TO: All Prospective Proposers FROM: Maryland Transit Administration SUBJECT: Addendum No. 1 T-1994-0250 OWINGS MILLS METRO PARK AND RIDE REHABILITATION DATE: DECEMBER 4, 2023 Addendum No. 1 is three (3) page and includes the following: ITEM No. 1 --- Provides SIGN-IN SHEETS for the PRE-BID CONFERENCE for T-1994-0250 OWINGS MILLS METRO PARK AND RIDE REHABILITATION held on Wednesday, November 29, 2023 at 10:00 AM. EST. ITEM No. 2 --- Provides SIGN-IN SHEETS for the SITE VISIT for T-1994-0250 OWINGS MILLS METRO PARK AND RIDE REHABILITATION held on Wednesday, November 29, 2023 at 2:00 P.M. EST All other terms and conditions remain unchanged. Sincerely, Christis C. Williams Christie E. Williams, CPPB Chief of Construction, Procurement Acknowledgement of receipt of Addendum No. 1 to T-1994-0250. Vendor Name: \_\_ Authorized Representative's Signature Date

SUBJECT: Addendum No. 2

T-1994-0250 OWINGS MILLS METRO PARK AND RIDE

DATE: January 10, 2024

CV03/ SCALE: NOT TO SCALE REF: CVO1, CVO2

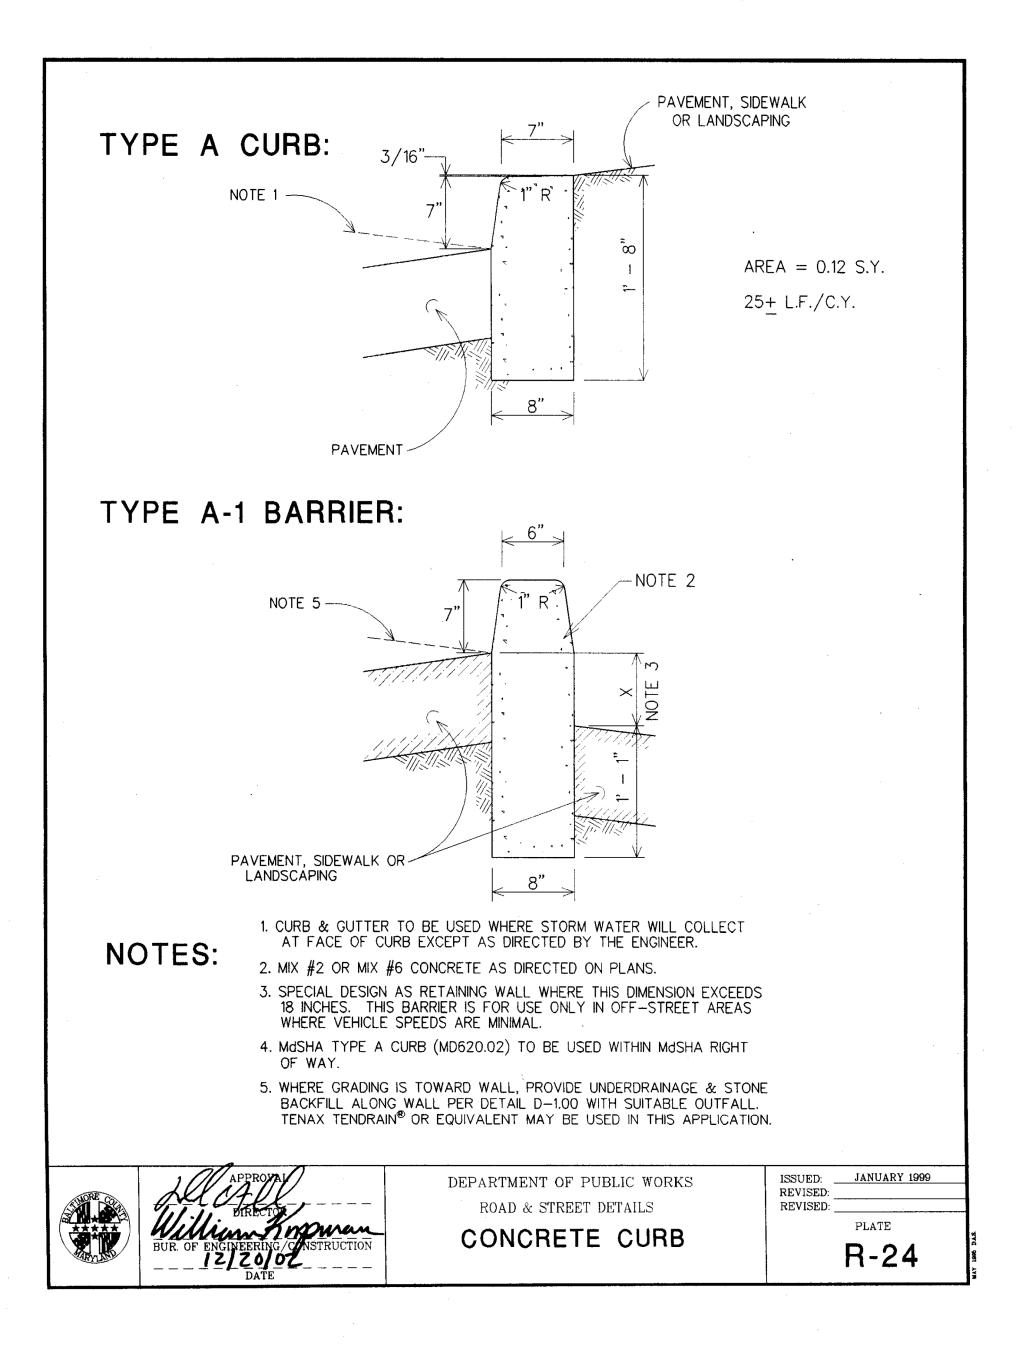
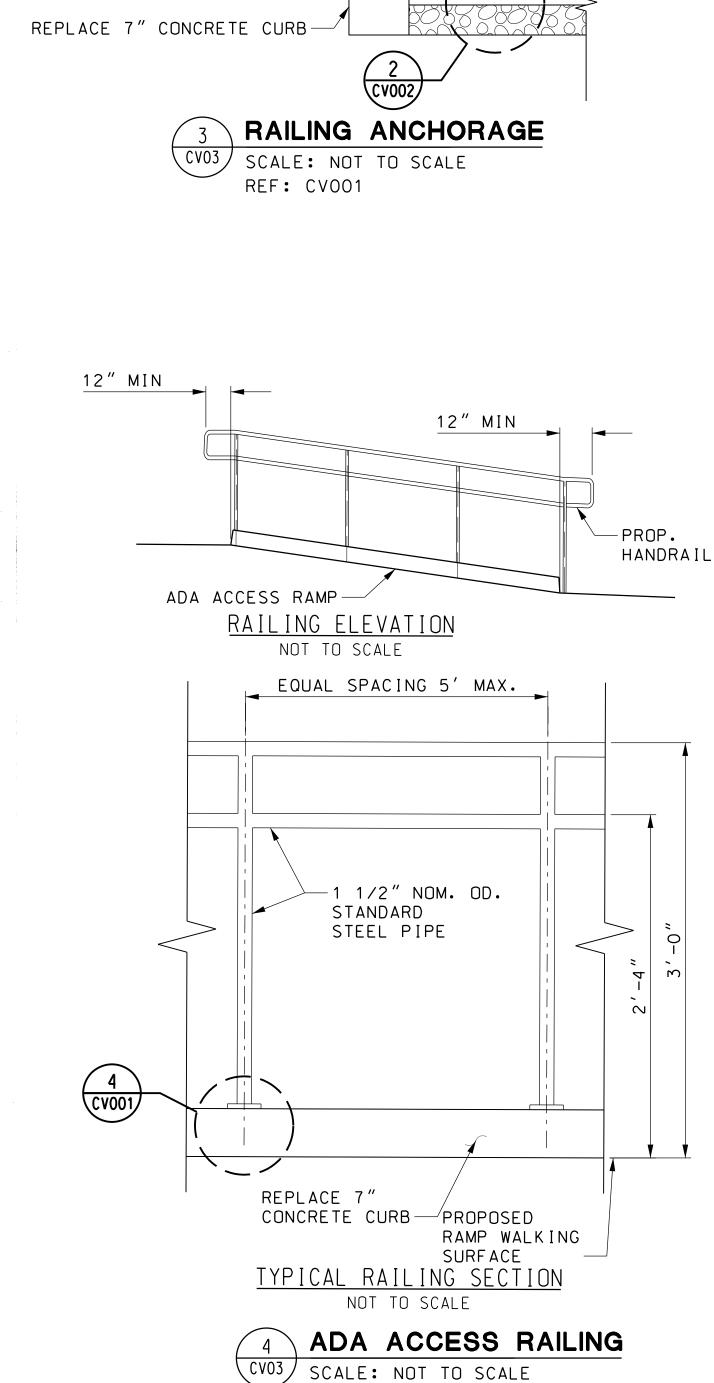
3. Detail 3 on sheet CV03 shows to replace 7" curb at the handrail location — but there is not an existing 7" curb to replace. Please advise.

RESPONSE: The detail is for the railing anchorage. Curb replacement is not part of the railing pay item.

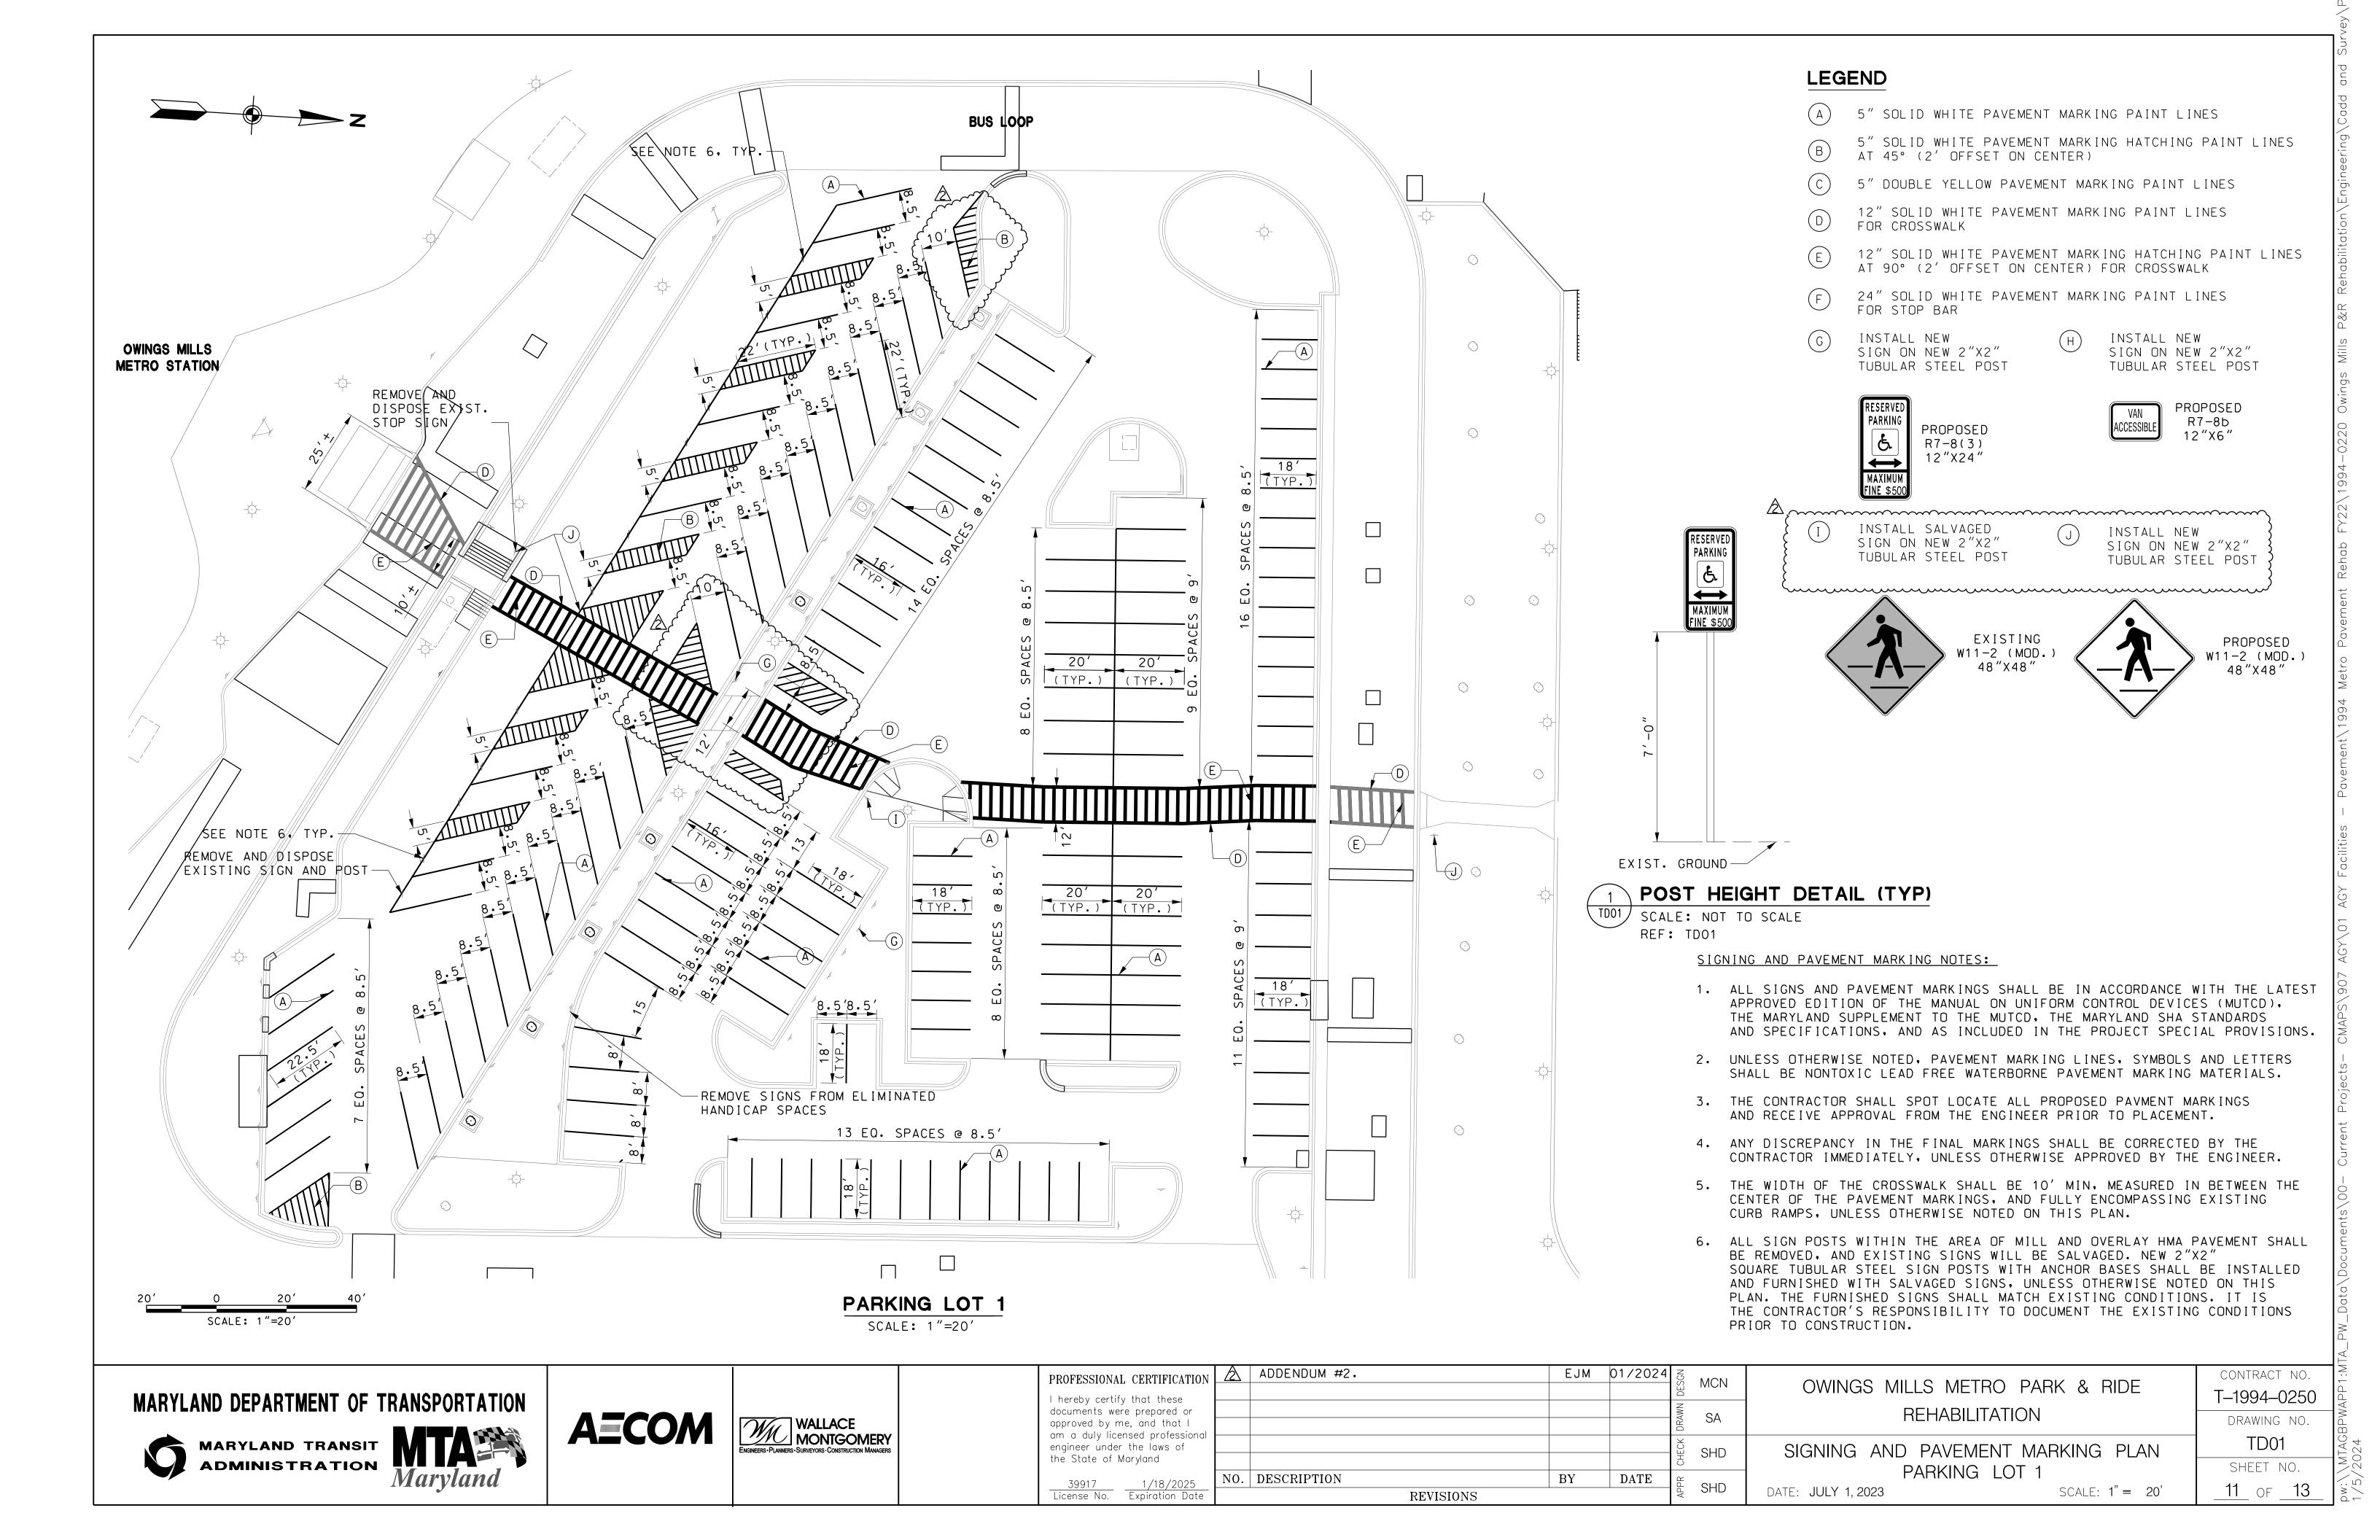
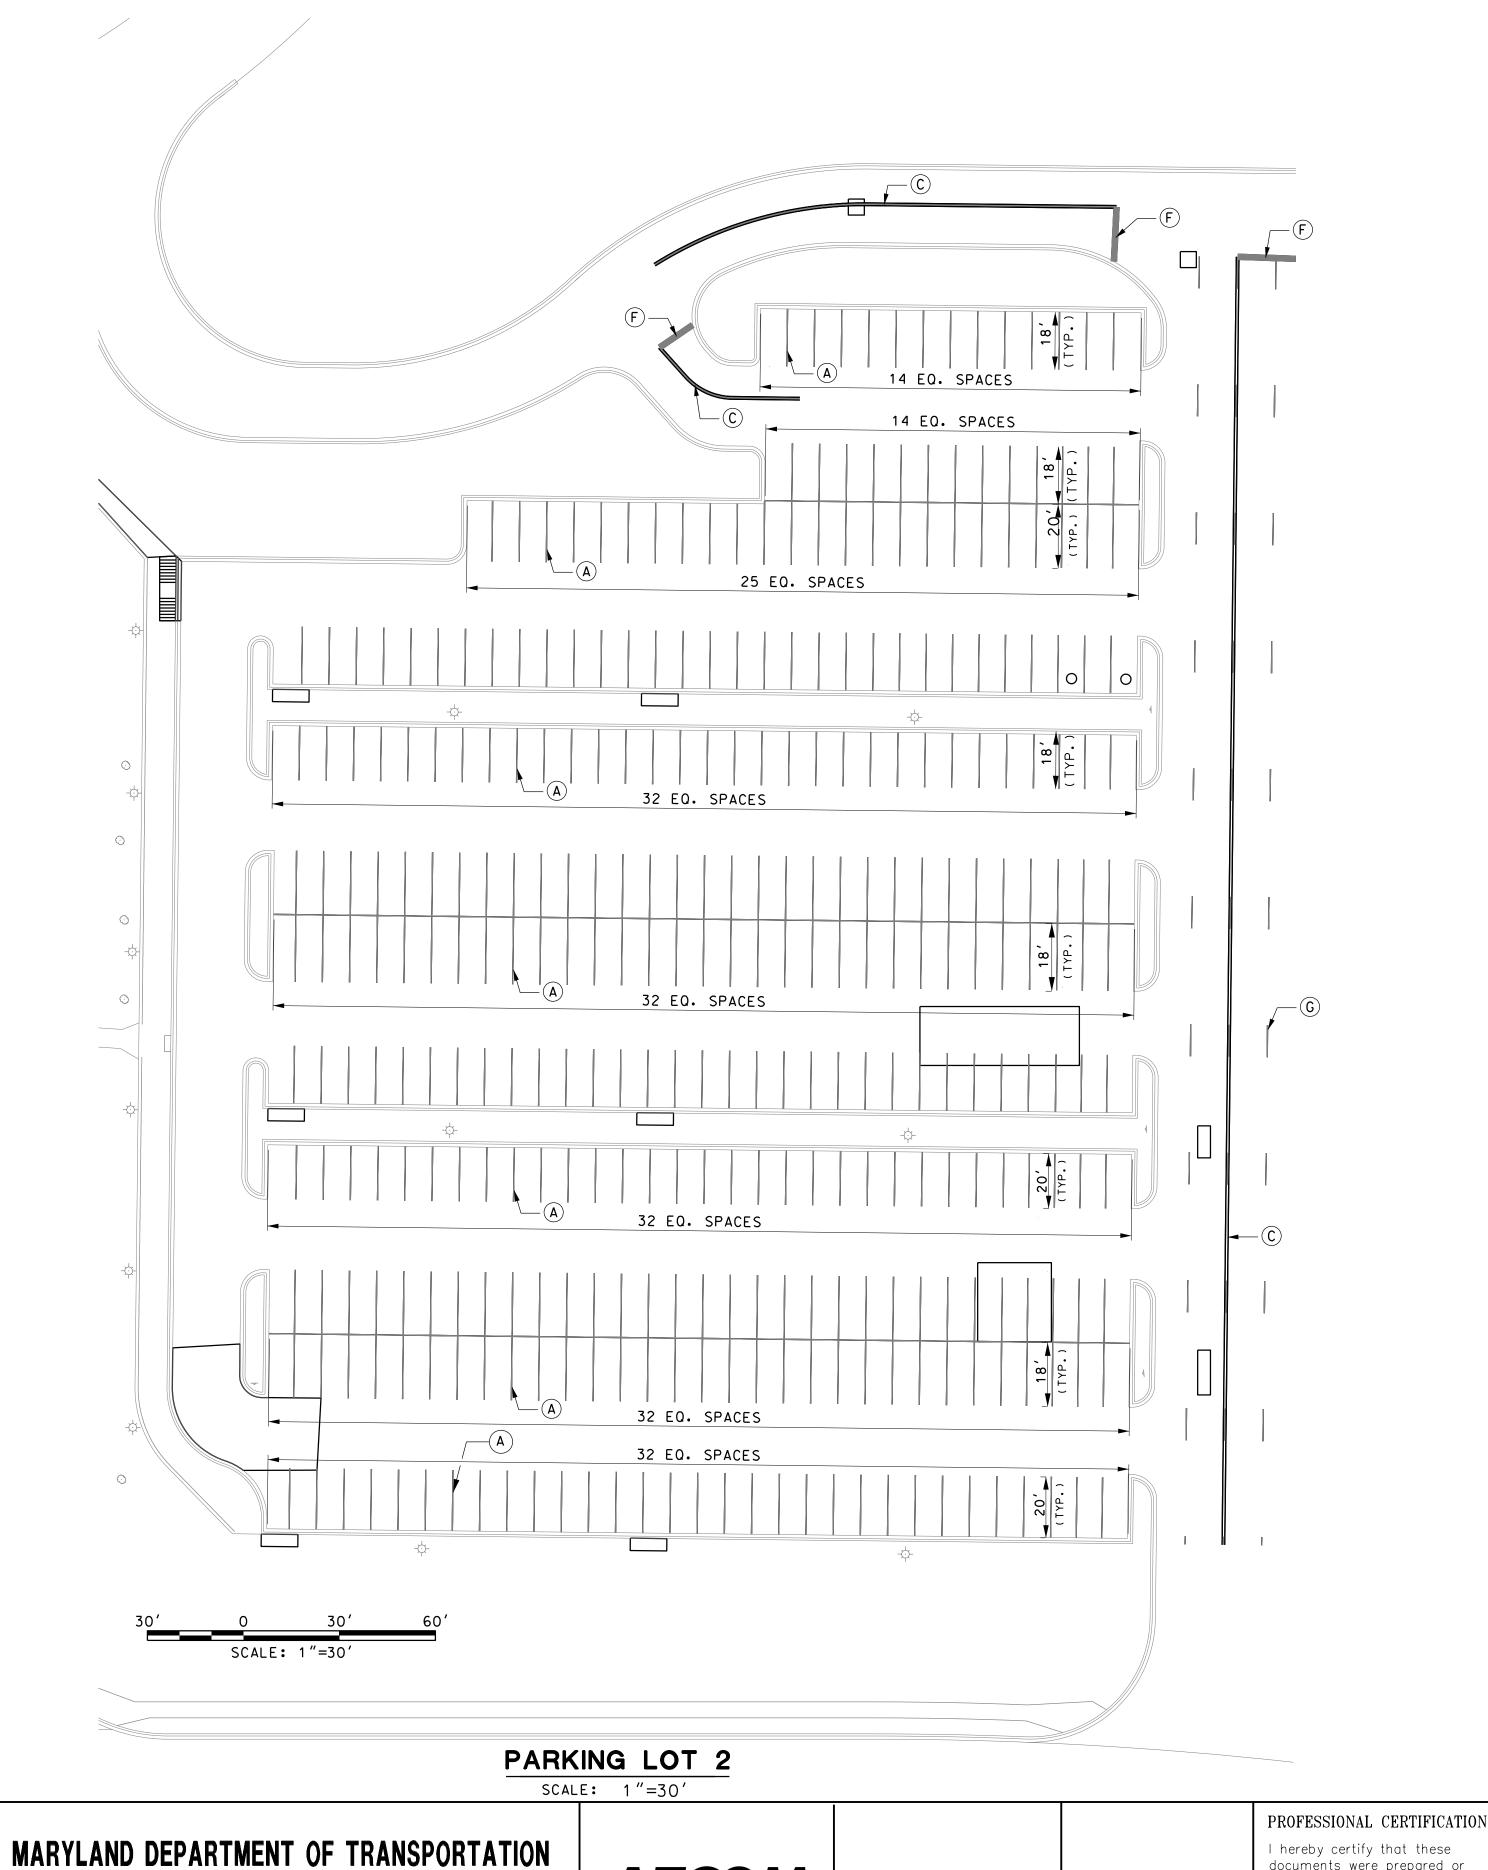
ITEM No. 4 --- Provides Revised plans to address temporary ADA sign configuration, remove reference to concrete bases for signs, revise quantity of sidewalk, give direction on crack sealing asphalt base after milling.
